Application Numbers: A-3-SCO-09-001 and A-3-SCO-09-001

1. **Revised Final Plans.** PRIOR TO ISSUANCE OF THE CDP, the Applicant shall submit two sets of Revised Final Plans to the Executive Director for review and approval. The Revised Final Plans shall be substantially in conformance with the Site Plan prepared by Matson Britton Architects dated May 21, 2015 (Site Plan), attached hereto as Exhibit 3, but shall show the following changes and clarifications to the projects:

SITE PLAN
SCALE: 1" = 16'

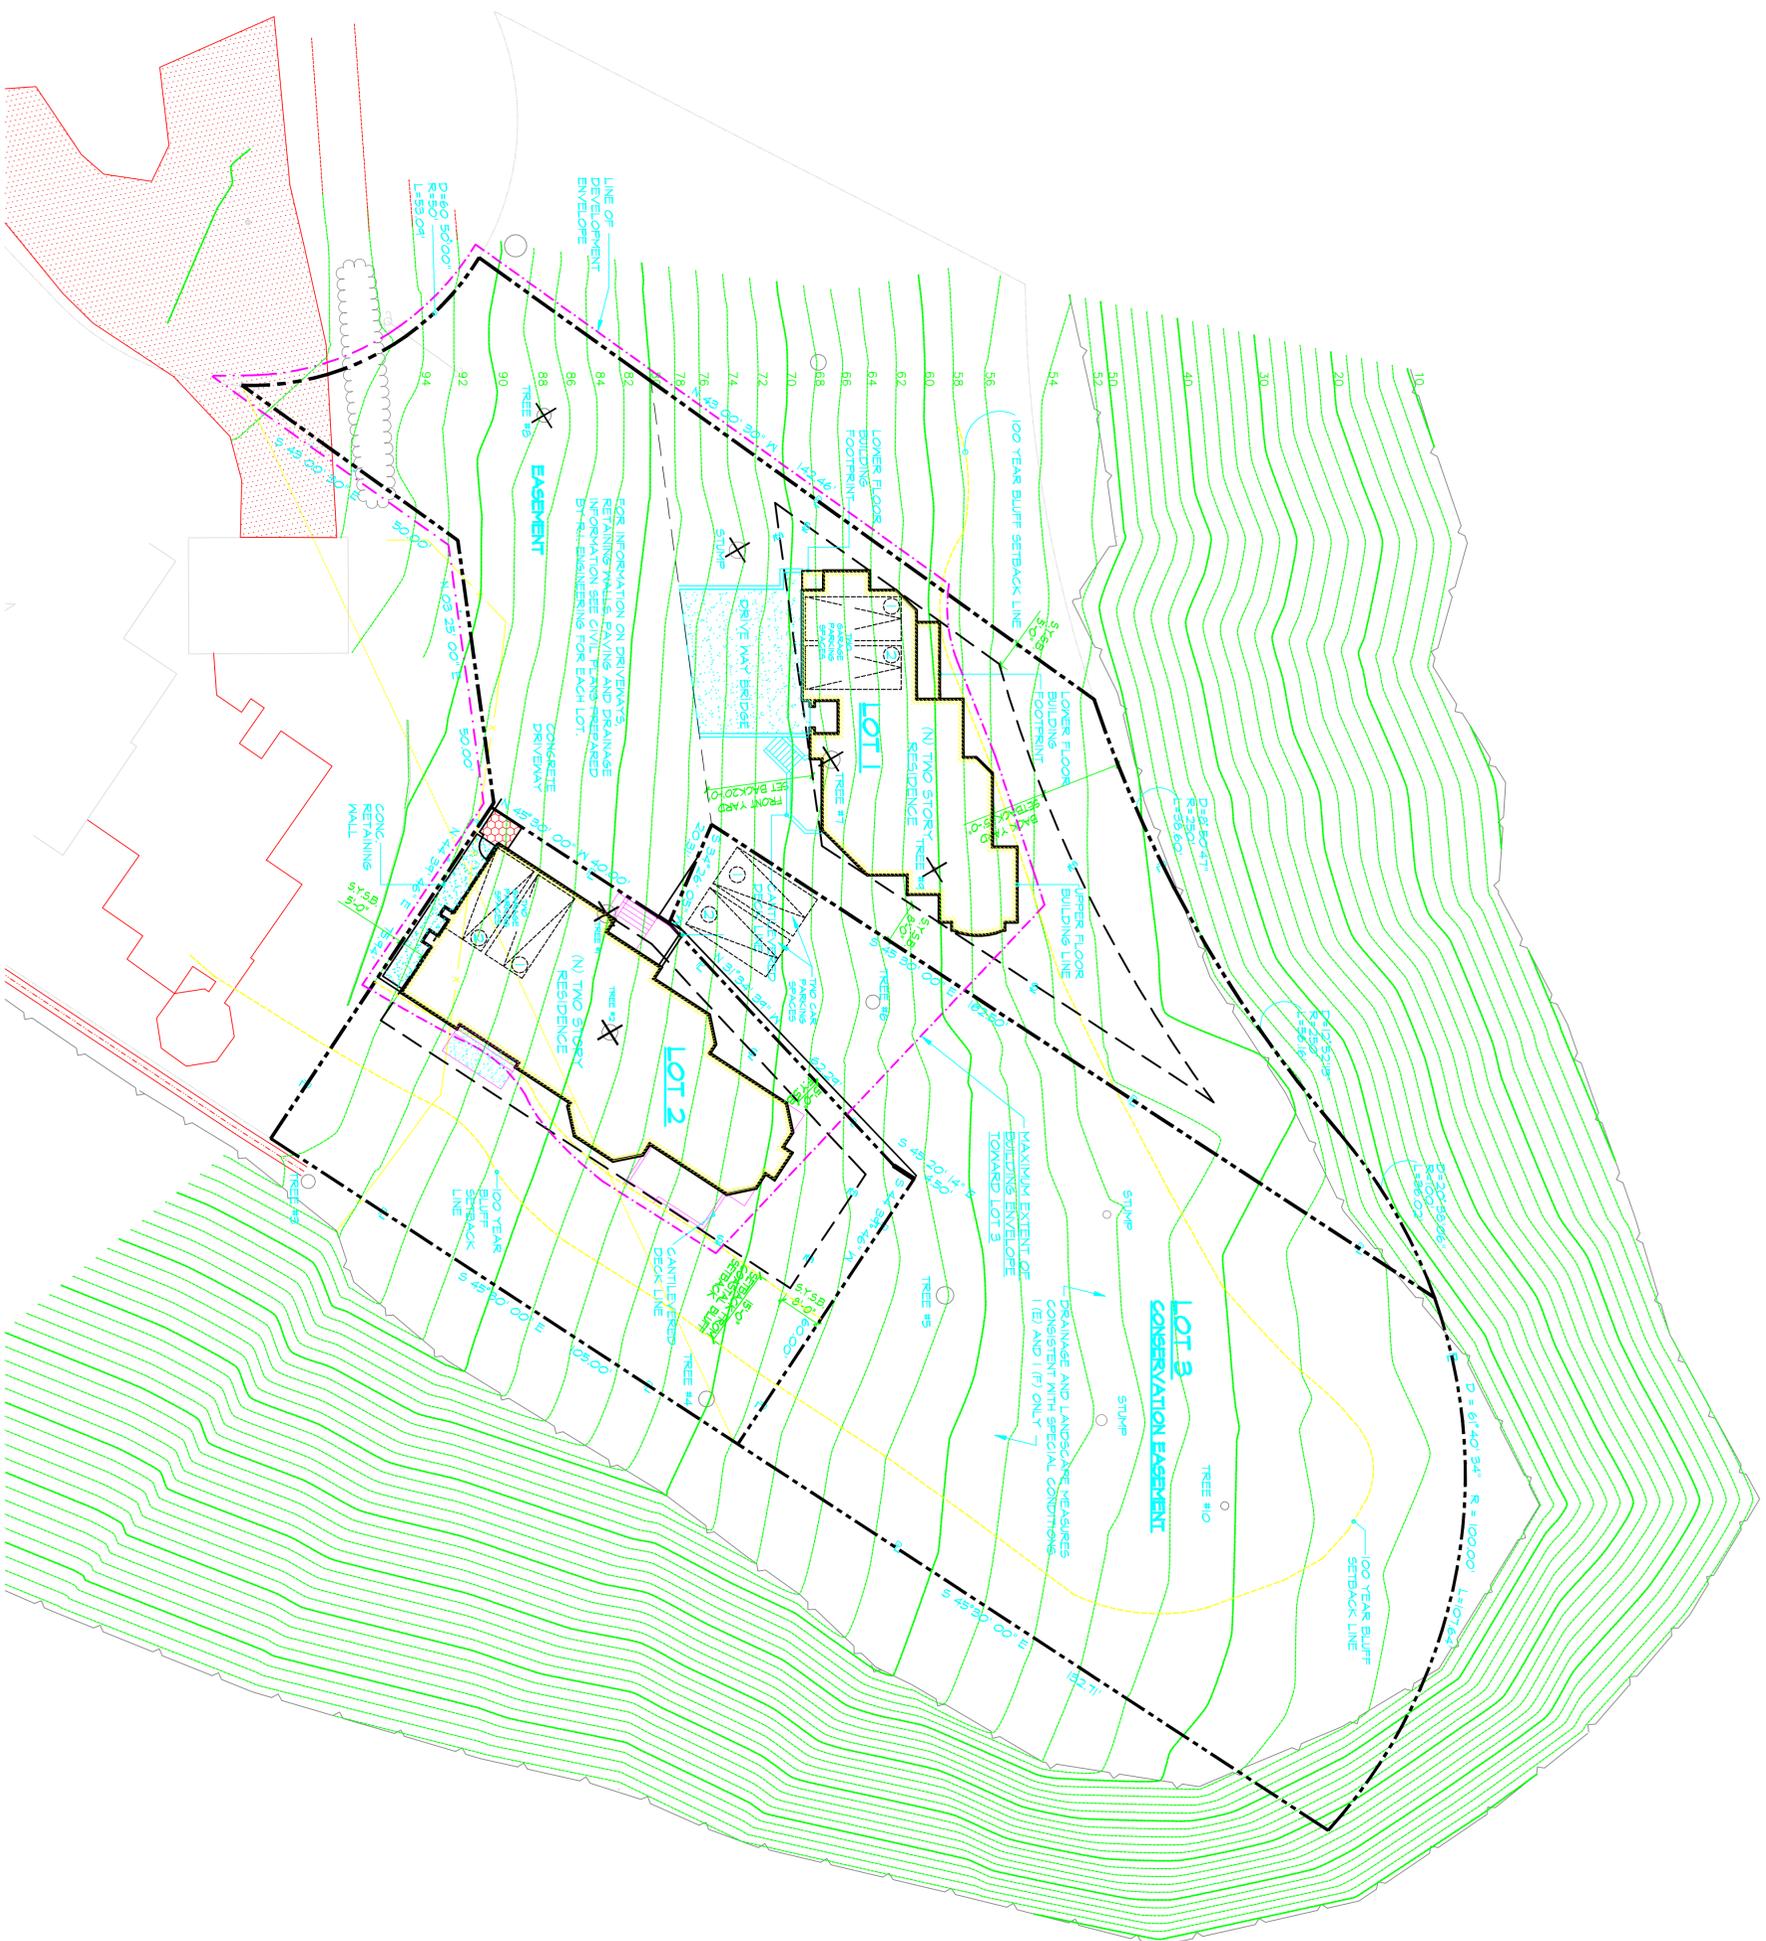
Specifically, for both Lot 1 and Lot 2, **Special Condition 1** requires the submission of revised plans that are in substantial conformance with the submitted site plan (**Exhibit 3**) including a defined building envelope for Lots 1 and 2 and a portion of Lot 3. The projects are also conditioned to require that the Applicant acknowledge that the sites are subject to extreme coastal hazards, including episodic and long-term shoreline retreat and coastal erosion, high seas, ocean waves, storms, etc., and that the Applicant and all successors in interest assume all risks for development in an area subject to coastal hazards (See **Special Conditions 4, 5 and 6**). Furthermore, **Special Condition 5(b)** expressly prohibits the use of any type of shoreline protective device for the purpose of protecting the proposed development and **Special Condition 5(c)** waives any future right to a shoreline protective structure for the proposed development. **Special Conditions 5(d) and (e)** further require that the Applicant report to the Commission in the event the edge of the bluff recedes to within ten feet of either residence, and require the property owner to remove and/or relocate any development that becomes threatened by coastal hazards and restore the site. **Special Condition 6** ensures that any redevelopment of the approved development be sited and designed to ensure geologic and engineering stability without reliance on shoreline protective devices. Finally, **Special Condition 9** requires the record owner of Lot 3 to submit proof to the Executive Director that the owner has voluntarily recorded a conservation easement over Lot 3.

- (a) **Approved Building Envelope.** All development (including but not limited to residences, driveways, parking areas, drainage systems and septic systems) shall be located on Lots 1, 2 and the portion of Lot 3 directly in between Lots 1 and 2, within the building envelope and in the general configuration shown on Exhibit 3 (the Site Plan). Development shall be prohibited outside of the approved building envelope except for restoration, drainage improvements (consistent with Special Condition 1(e)), landscaping to create a visual buffer (consistent with Special Condition 1(f)), underground utilities (including sewer, gas, electrical, plumbing and cable), temporary activities and facilities necessary for construction of the houses as shown (including but not limited to grading and excavation), and a patio on Lot 2 provided that the construction activities are minimized to the maximum extent feasible and are kept as close to Bayview Drive as possible, and all impacted areas outside the building envelope are restored and landscaped following completion of construction, pursuant to Special Condition 1(f).

Figure 1. At left is Figure 6, reproduced from Church and others (2008)

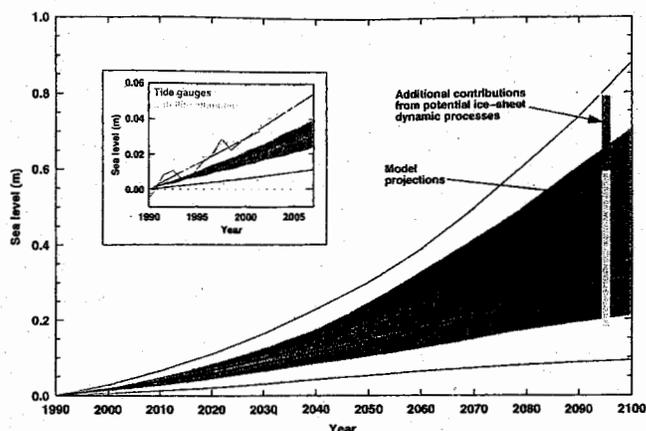
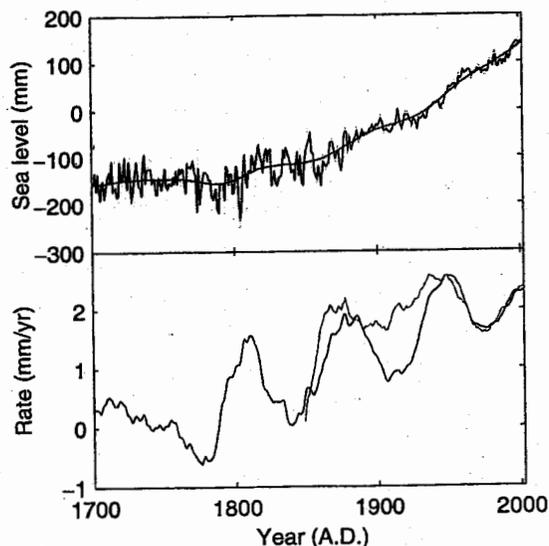
Based on the range shown in Figure 1, I suggest that a reasonable assumption for sea level rise in the next century, to be applied to geological hazard and risk analyses for single family residences, is as follows:

Figure 11. Wave erosion at subject properties – January 23, 1983. The only time the beach has been stripped in the past 39 years. Evidence that the base of the erosional sea cliff is above the level of wave attack.

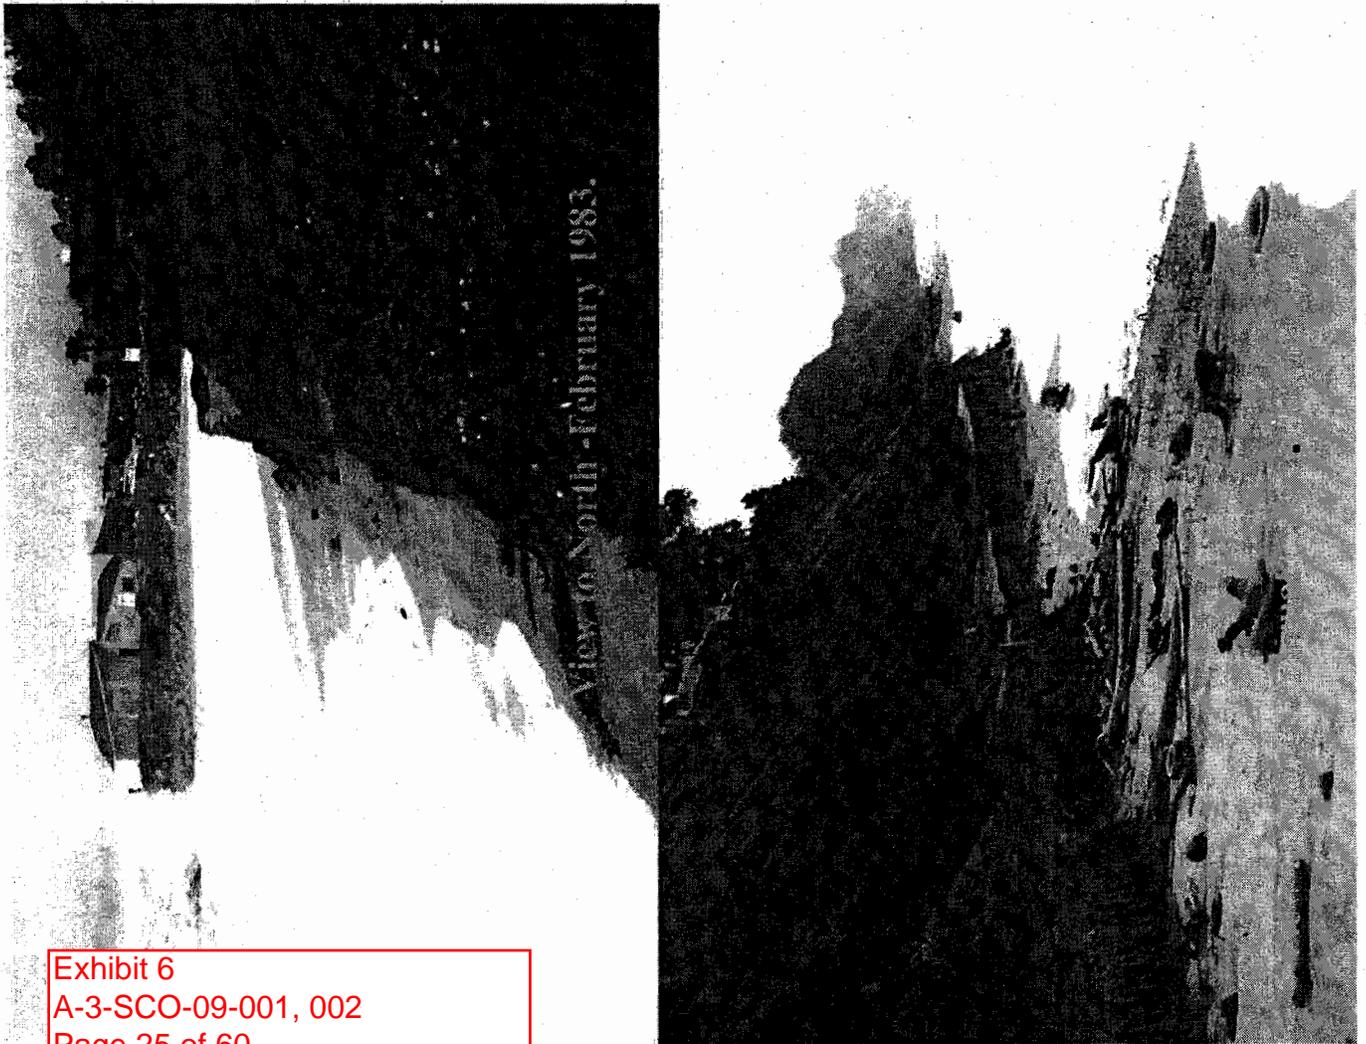
The same storms severely damaged homes along Via Gaviota and at Pajaro Dunes (Figure 13) and elsewhere along the northern Monterey Bay shoreline. The homes at Pajaro Dunes which are built at the upwind edge of an active dune field on the active beach were severely damaged. Yet a short distance north at Sunset Beach (Figure 13) the waves created only a small scarp in the colluvial wedge at the base of the sea cliff. At Hidden Beach which fronts the subject property, the same storms stripped sand off of the beach exposing the risers for the sewer line, but only slightly eroded into the toe of the colluvial wedge at the base of the cliff (Figure 11).
